*STP-209-1(2) Roadway and BHF-209-1(3) Bridge  
Widening of SR 74 From SR 85 to*

*P.I. Nos. 322355 and 322357*

**Value Engineering Study Report**

Preliminary Design Stage

Sht. 5 of 16  
ORIGINAL DESIGN

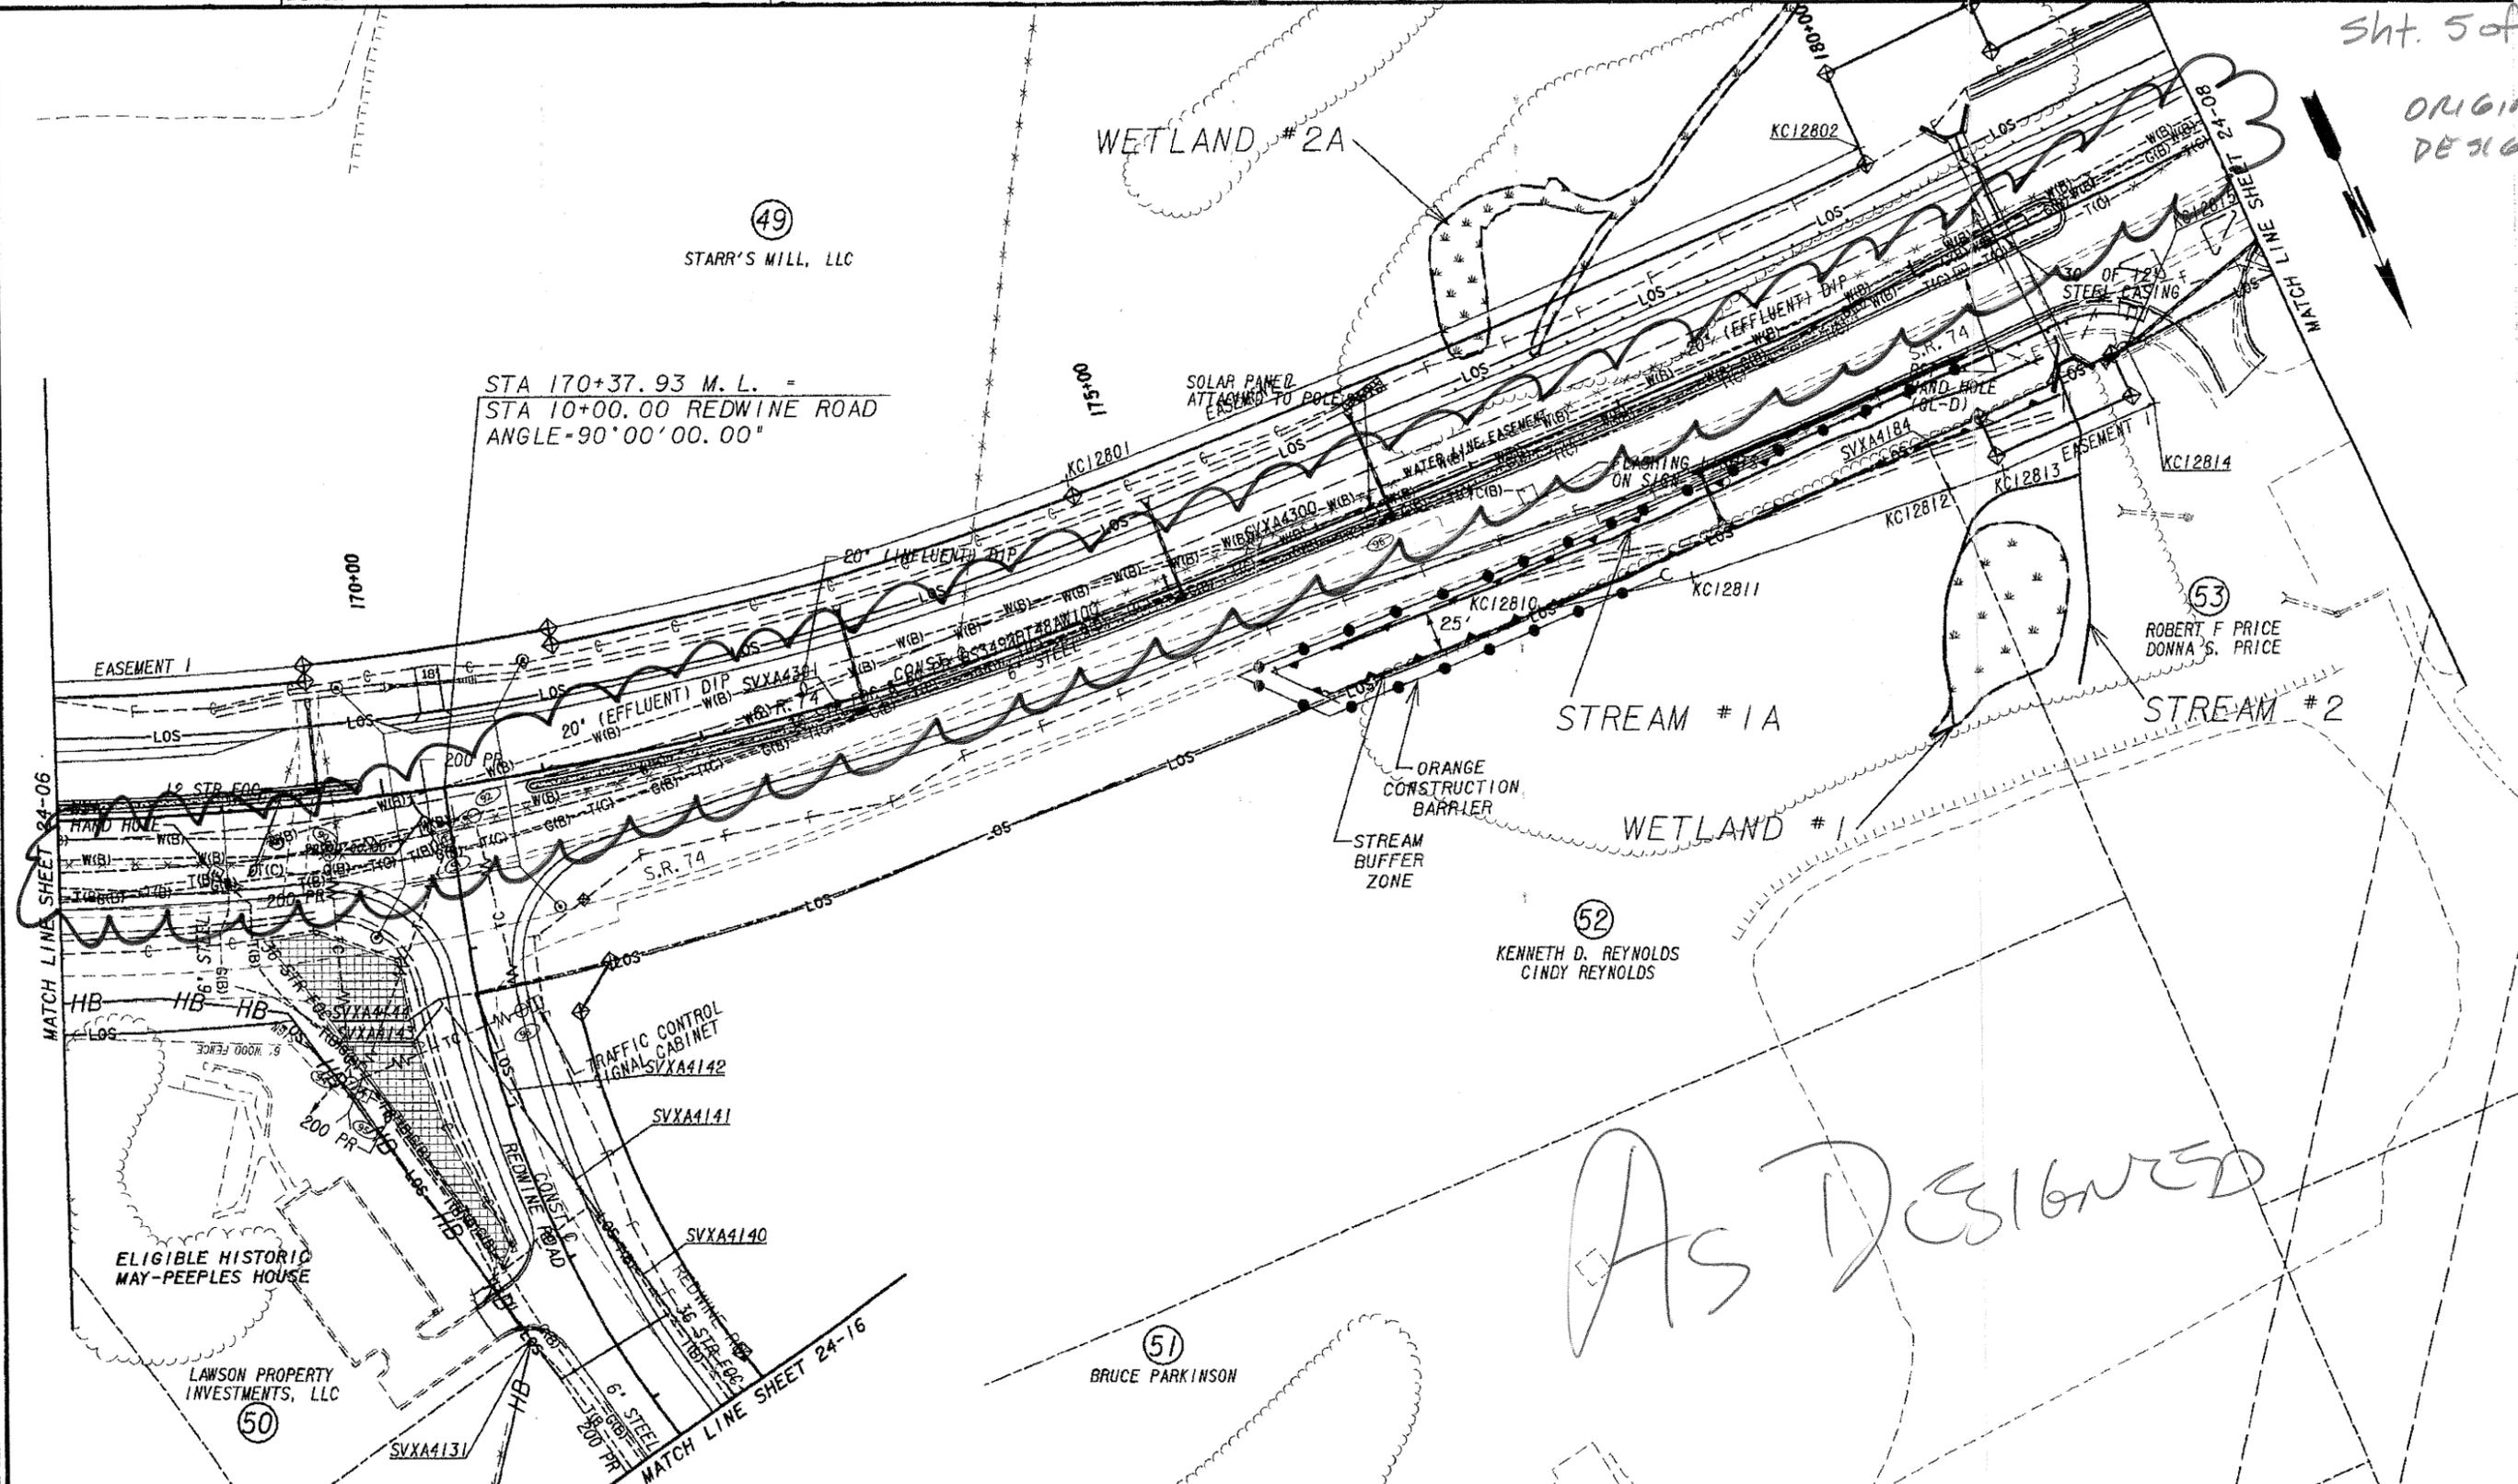
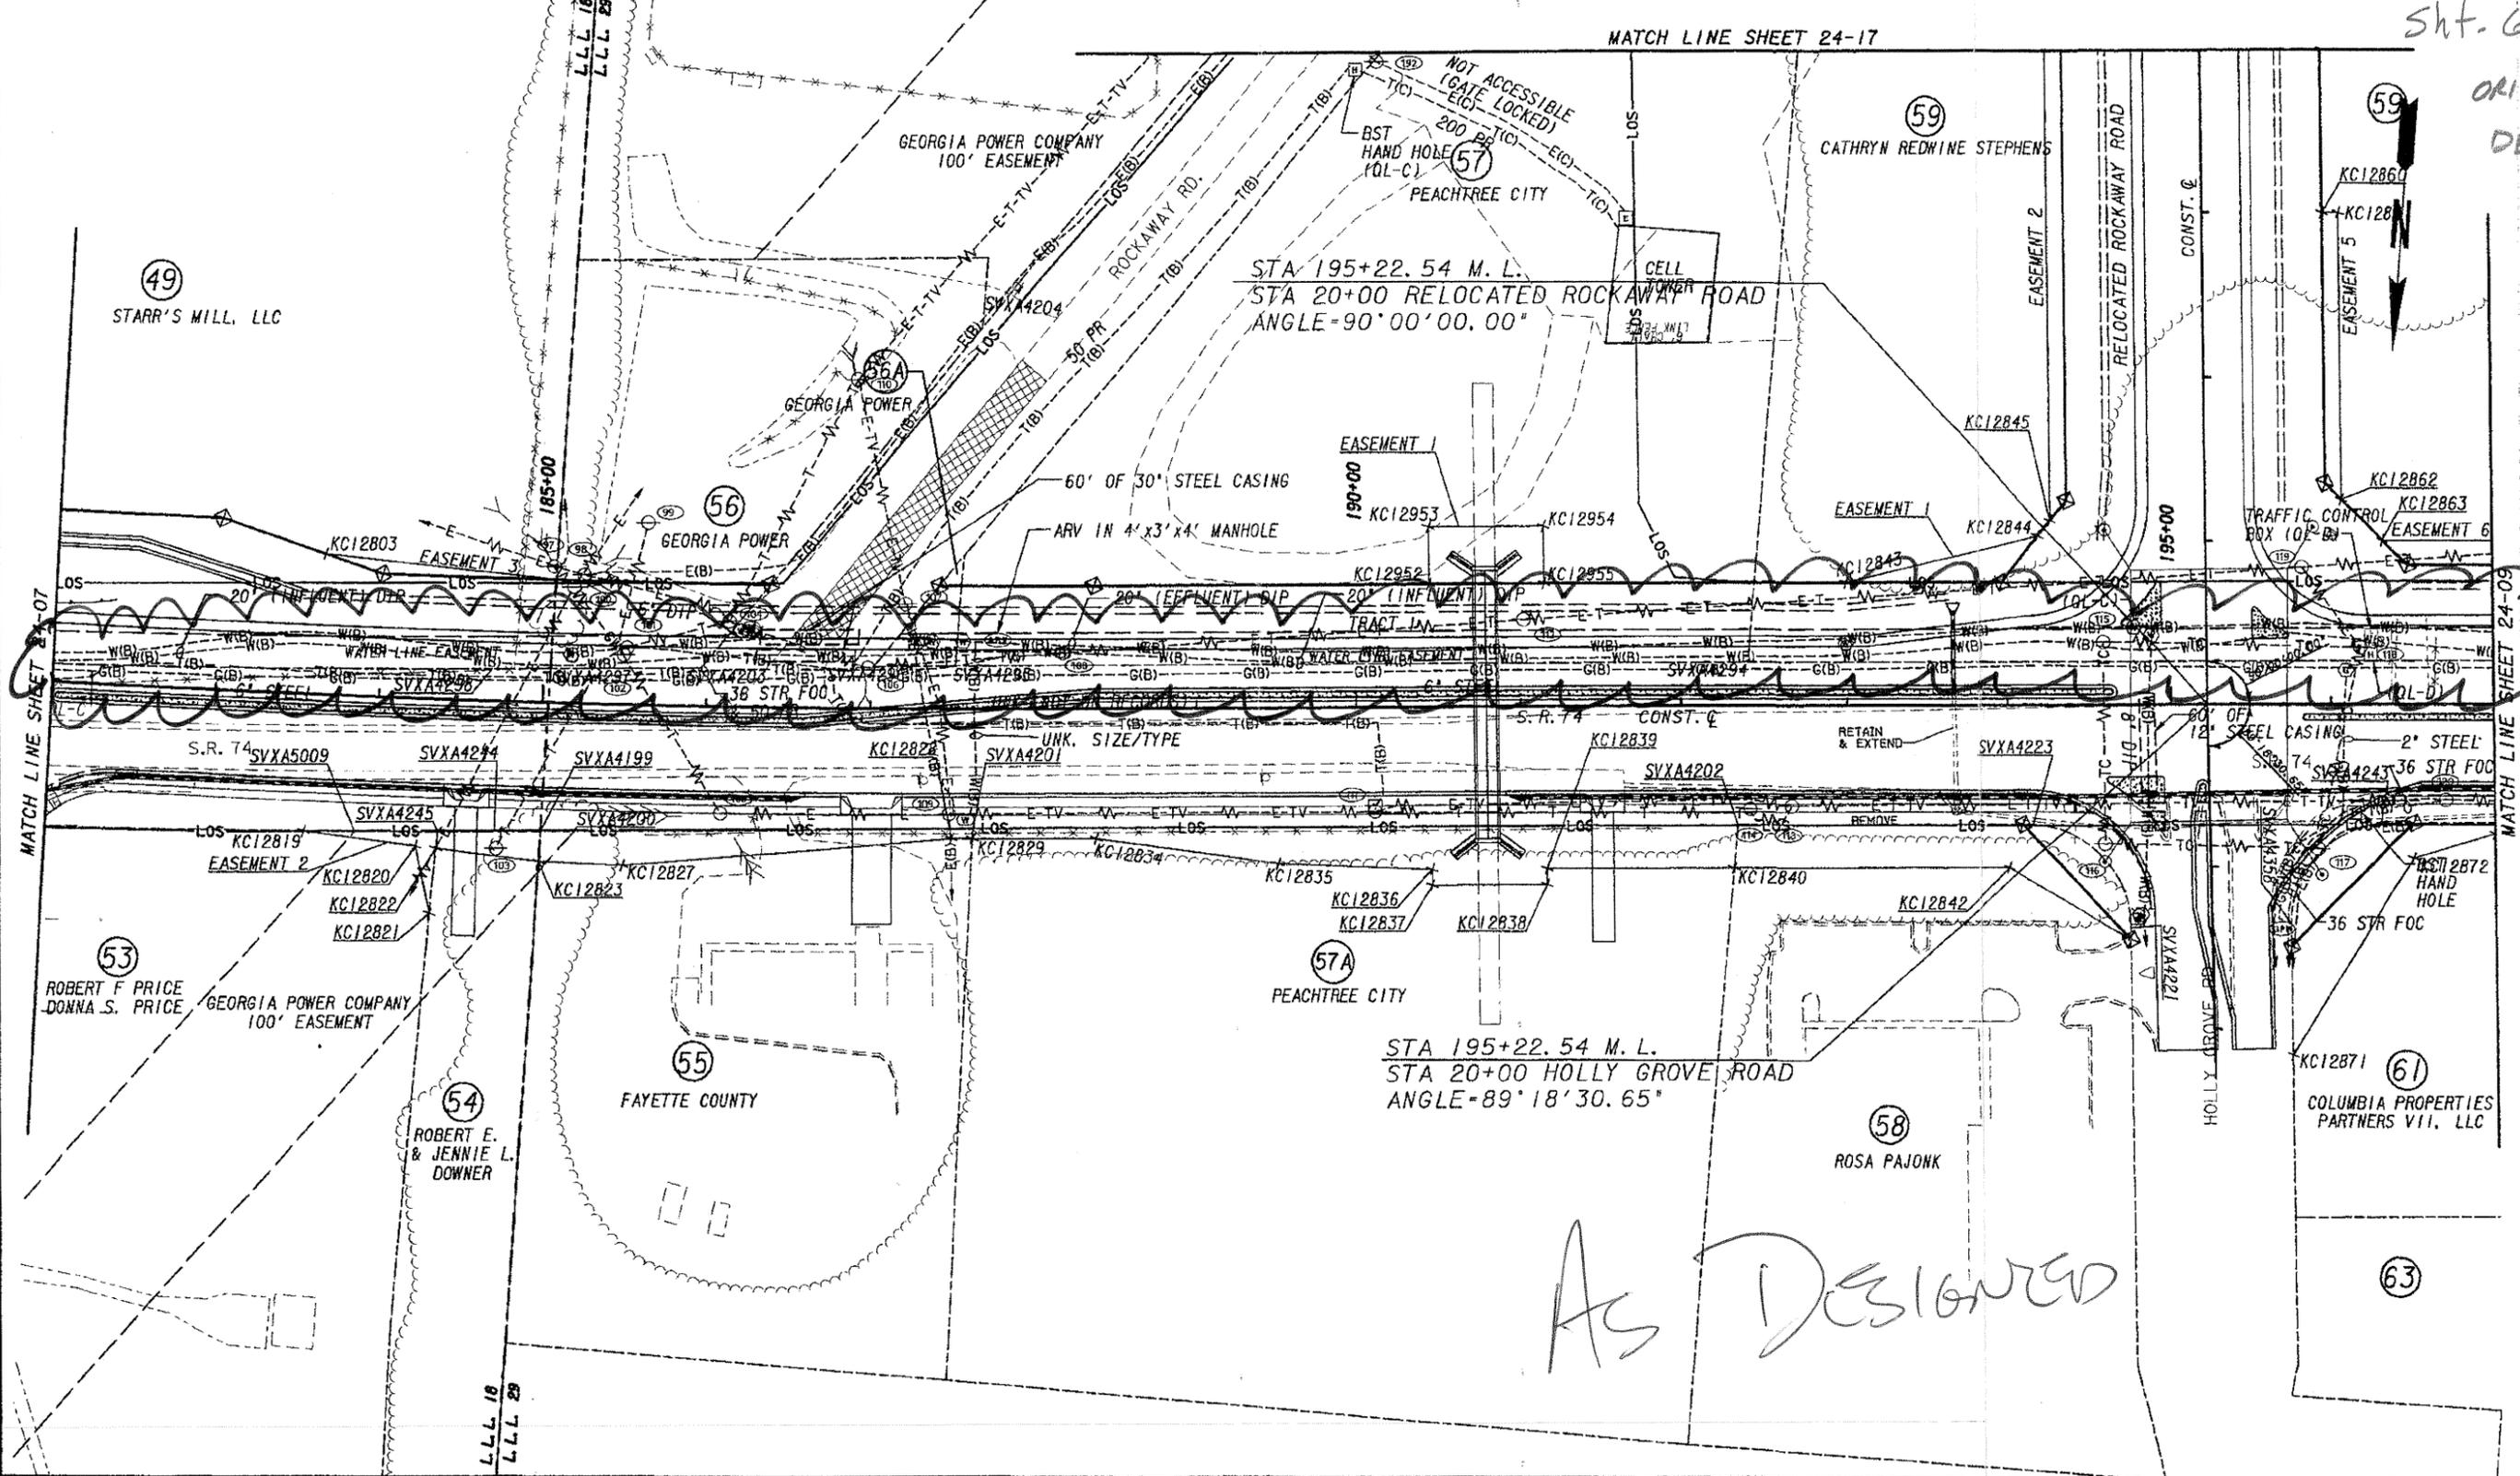
The current design assumes that the water lines are inexpensive and easy to relocate. The lines are trunk lines from the Peachtree City Water Treatment Plant. An effort has been made to avoid these lines outside of the station limits below.

With housing distances from the road often exceeding 100 ft., there does not appear to be a valid reason why the horizontal alignment can not be shifted to avoid the water lines. The right-of-way costs would not appreciably change, but amounts would be shifted from one side to the other.
